Design Review Subcommittee (DRSC)

SUBJECT: **Architectural Permit 14-389/Variance 14-474/Conditional Use Permit 14-475 – Capistrano Shores Wall and Landscaping** a request to consider a variance for a decorative block wall with accent columns in excess of six feet in height between the railroad tracks and the Capistrano Shores Mobile Homes Park, along with a Conditional Use Permit to allow the accessory structures, landscaping, and utility improvements in an open space zone at 1880 N. El Camino Real within the Open Space zoning district and Coastal Zone Overlay (OS2-S2-CZ).

Exhibit 1: Main Entry

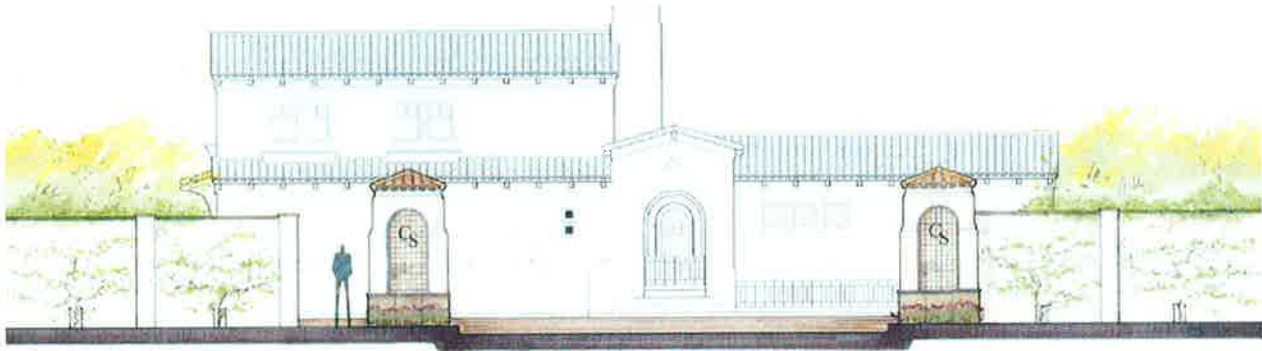
The project includes the construction of an eight-foot tall decorative smooth white stucco wall spanning the length of the Park; approximately 3,615 feet according to the City's GIS. At the main entrance the applicant is proposing to have two entry monuments flanking the drive aisle (See Exhibit 1.) Although signage is shown on the plans, it is not part of this application and will be reviewed at a later date.

The elevations include an eight-foot tall smooth white stucco wall with decorative cap, columns, and vines. At the main entry, the applicant proposes two accent columns taller than the wall standing 11'1" tall and five-feet wide. The entry columns propose a two-piece red tile cap. Arched insets with tile inlay will house future signs.

Exhibit 2: Columns and Trellis

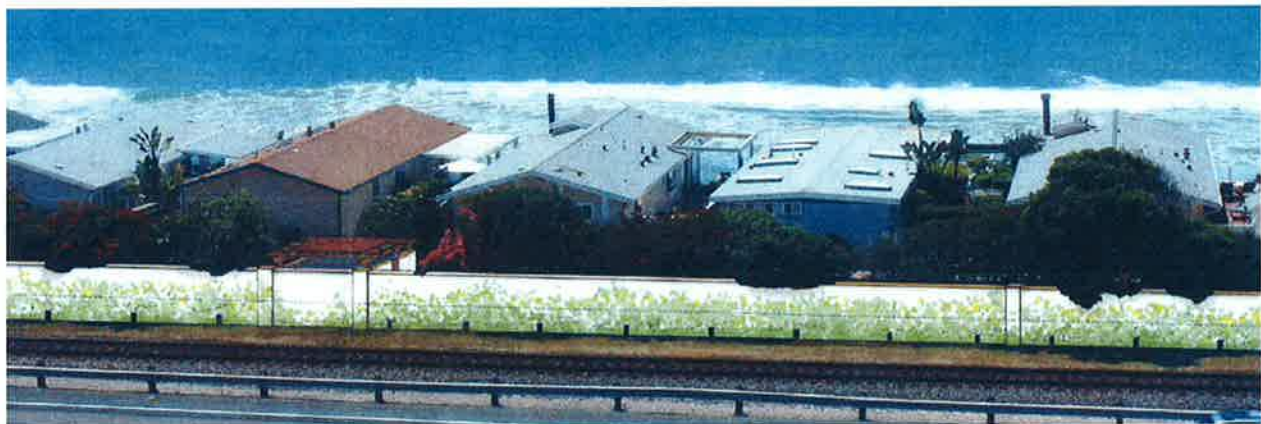
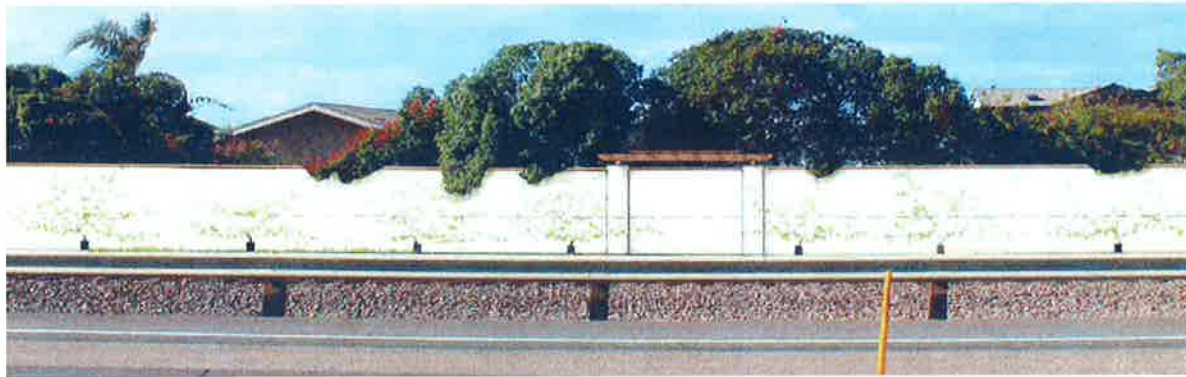
Articulation in the wall will be provided by a set of two columns visible from El Camino Real with a trellis on top that covers the trash enclosure located on the mobile home side of the wall. The element occurs every 185-300 feet. In the larger spans the applicant is proposing an additional single column for additional articulation. See Exhibit 2 for details.

**The columns are shown in the renderings but need to be added to the plans prior to Planning Commission.*
